# ADDENDUM NO. 2

February 23, 2024

Yorktown High School – Addition and Renovations 1100 South Tiger Drive Yorktown, IN, 47396

# TO: ALL BIDDERS OF RECORD

DRAWING NUMBER A900 PROJECT NUMBER

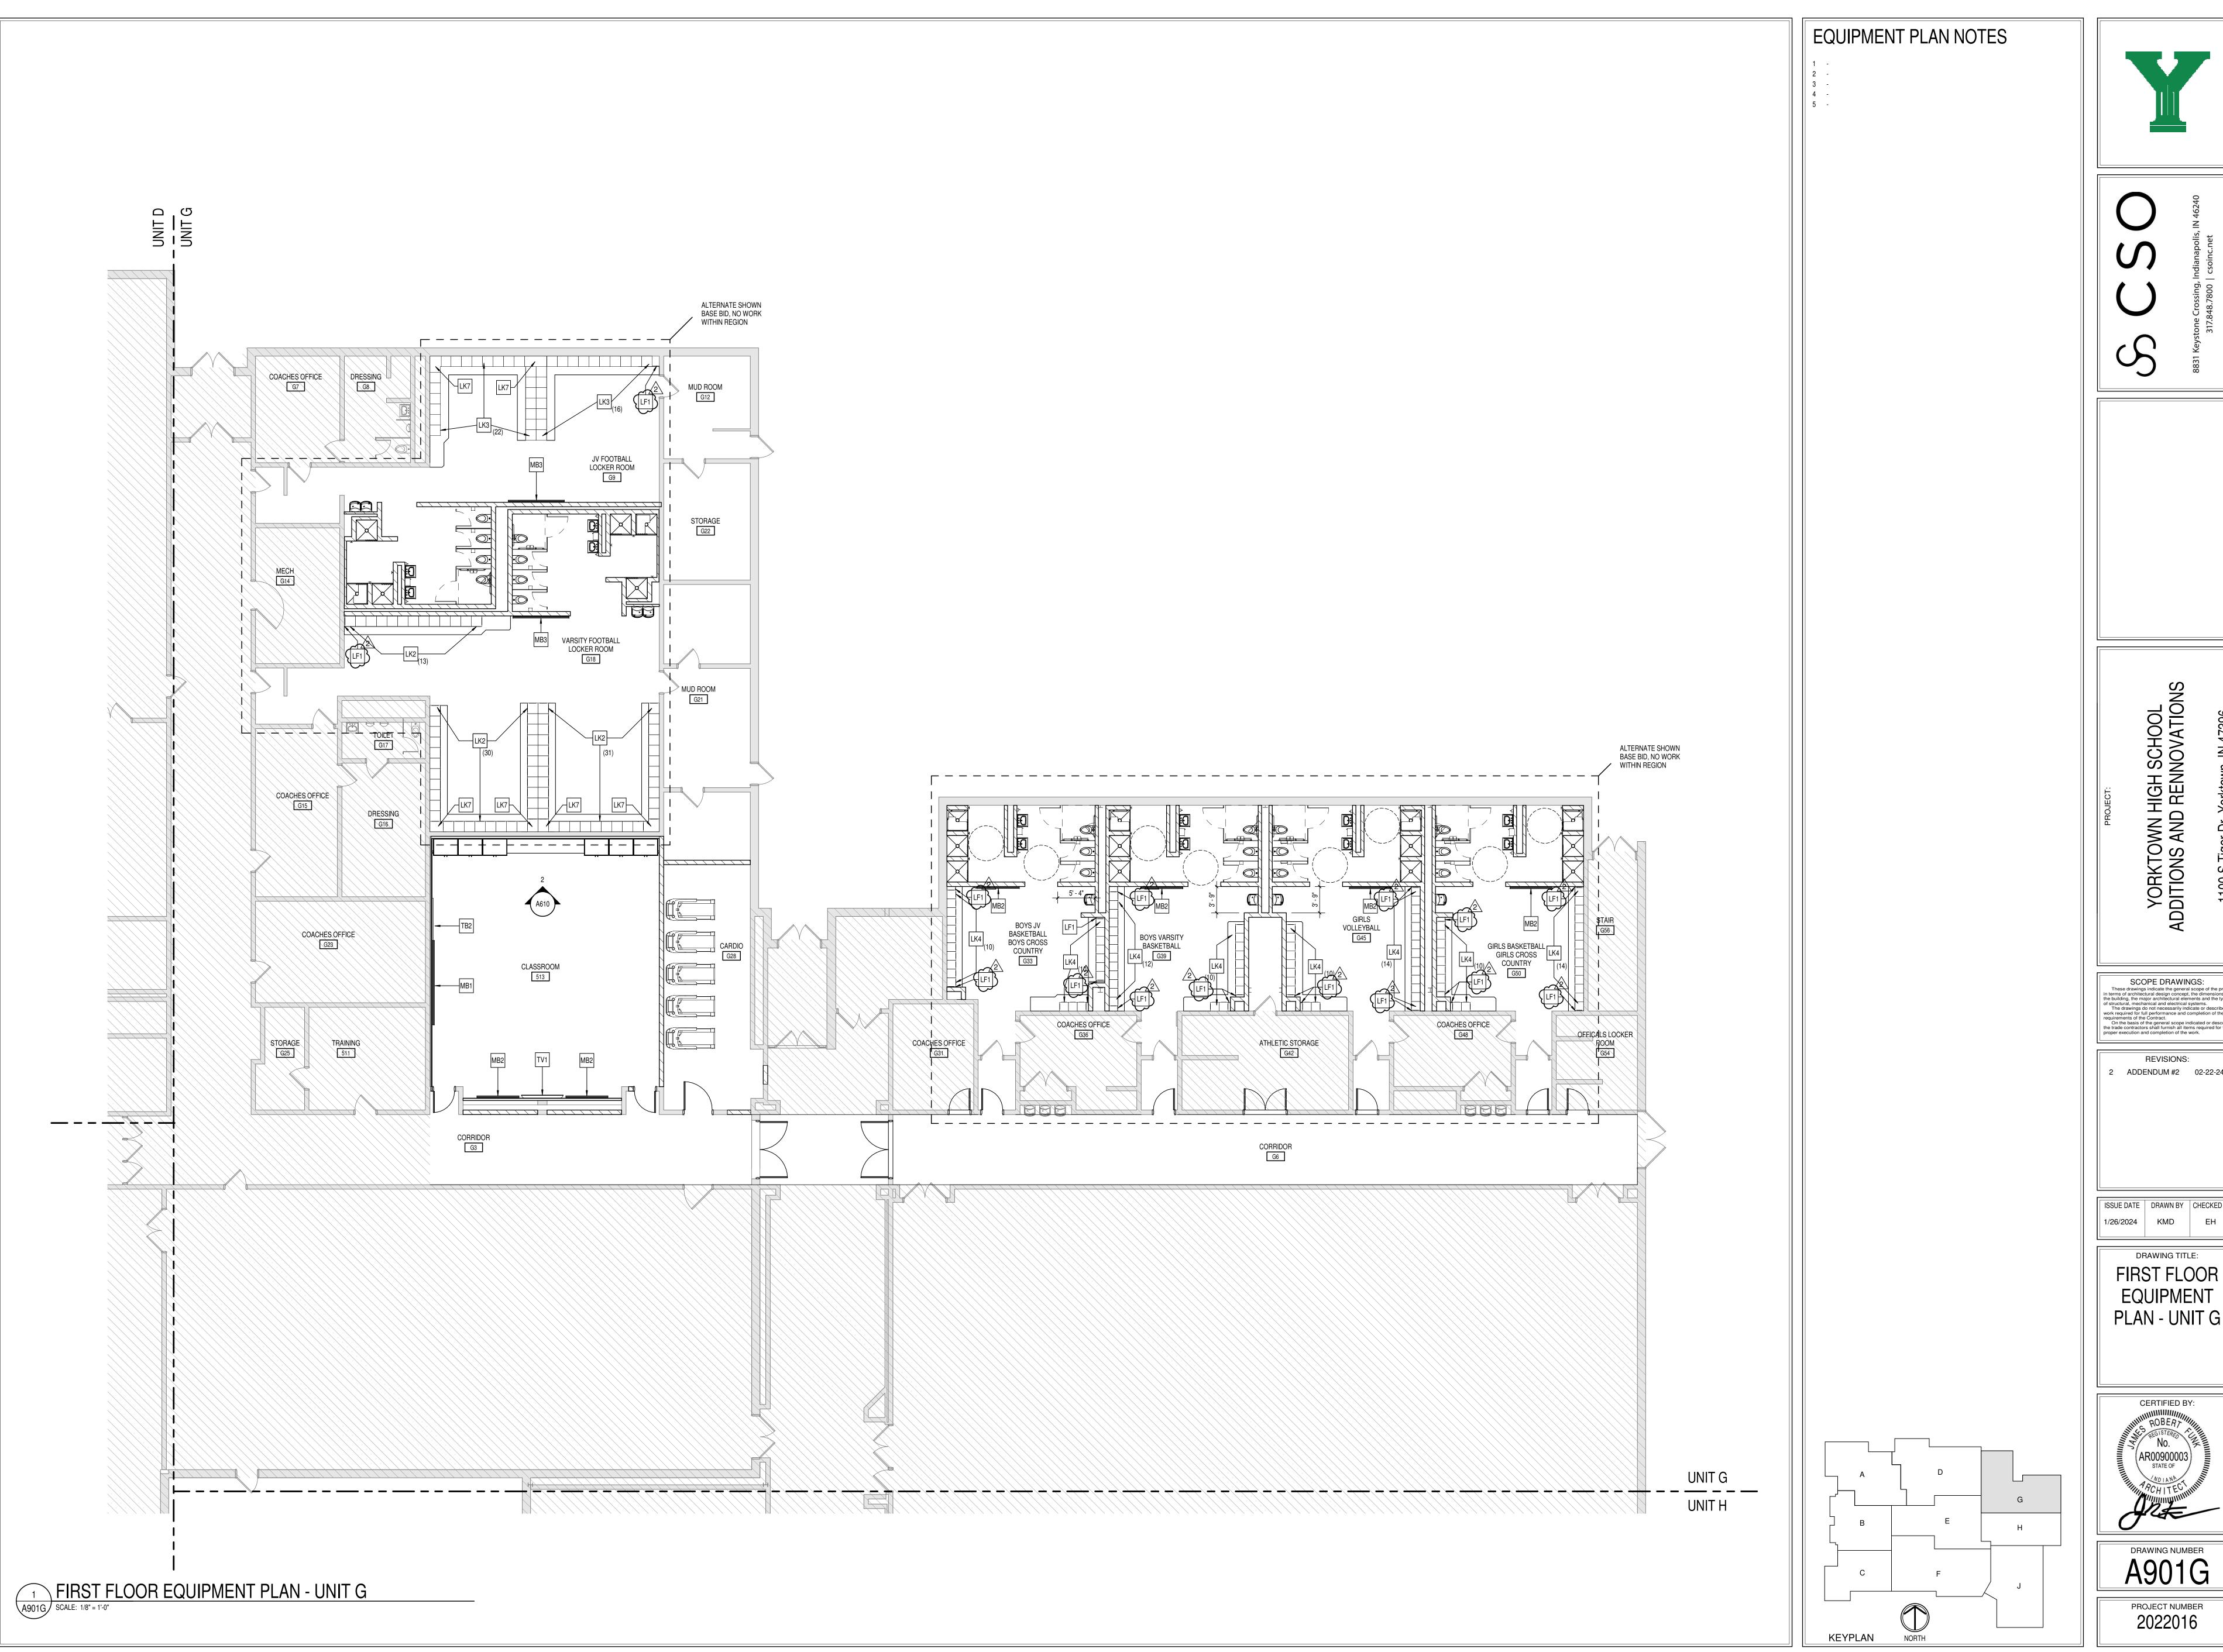
- A. Correct.
- 5.6 Sheet A900, GE2 Gym Bleachers has notation for a custom attachment to the PEMB. I am not able to locate any details on this. Can you please provide more information/details about this custom attachment? Need to know in order to understand how it affects the PEMB structure.
